Opinion on Energy Imbalance Market (EIM) Resource Sufficiency Evaluation Enhancements

Members of the Market Surveillance Committee of the California ISO

Draft of January 30, 2022

Figure 1. CAISO Flexiramp Requirements 2015. (Source: California ISO, Department of Market Monitoring, Q2 2015 Report on Market Issues and Performance, August 17, 2015, Figure 2.4, p. 44)

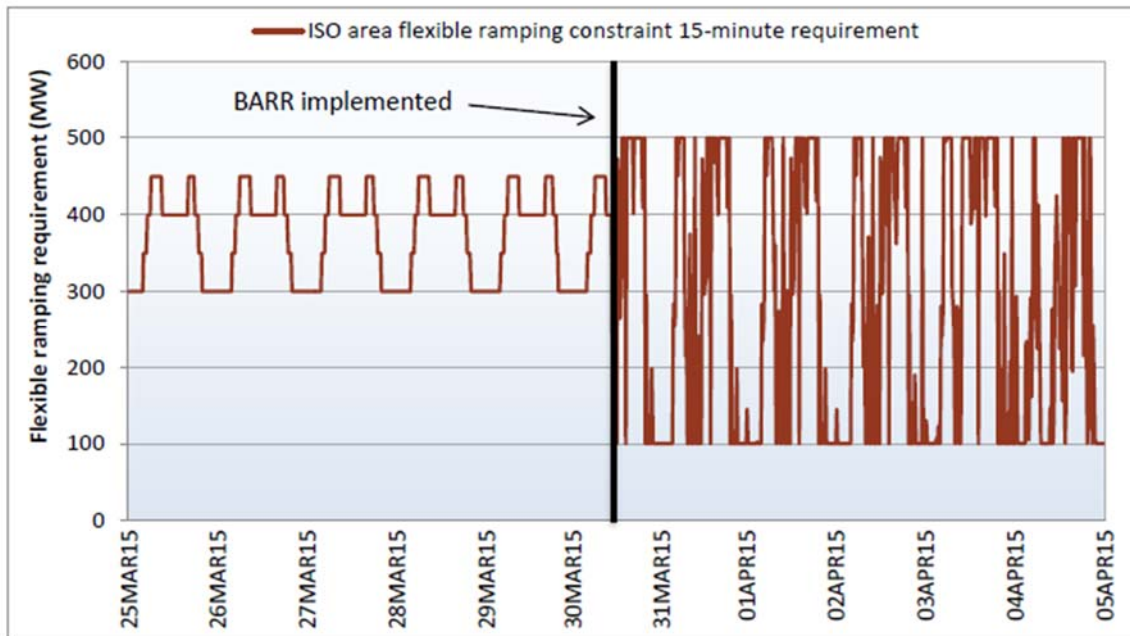
The impact of small sample size on the variability of estimates of the tail of a distribution is well illustrated by a graphic DMM prepared in 2015 to illustrate this point. The graphic portrays the variations in the CAISO flexible ramping required estimated using the BARR tool, which looked back over a limited number of intervals. The graphic shows clearly how the estimate swung back from the cap to the floor as small numbers of data points entered and exited the sampling period.¹¹ The number of data points included in the sample has been increased since 2015, so this figure does not show the current variability of the uncertainty requirement, but our point still applies: the necessary compromise between statistical precision (from enlarging samples) and avoiding bias (from avoiding enlarging samples to include less relevant data) results in samples that are too small to yield stable and precise estimates of tails of distributions and, thus, the requirements based on those tables.

¹¹ For instance, comparing the hour-by-hour requirements for April 5, 2015, with March 31, 2015 in the figure shows large differences although the sampling window used to construct the histograms differed by only 6 days. The instability over hours within a day also is at least in part an artifact of sample error.
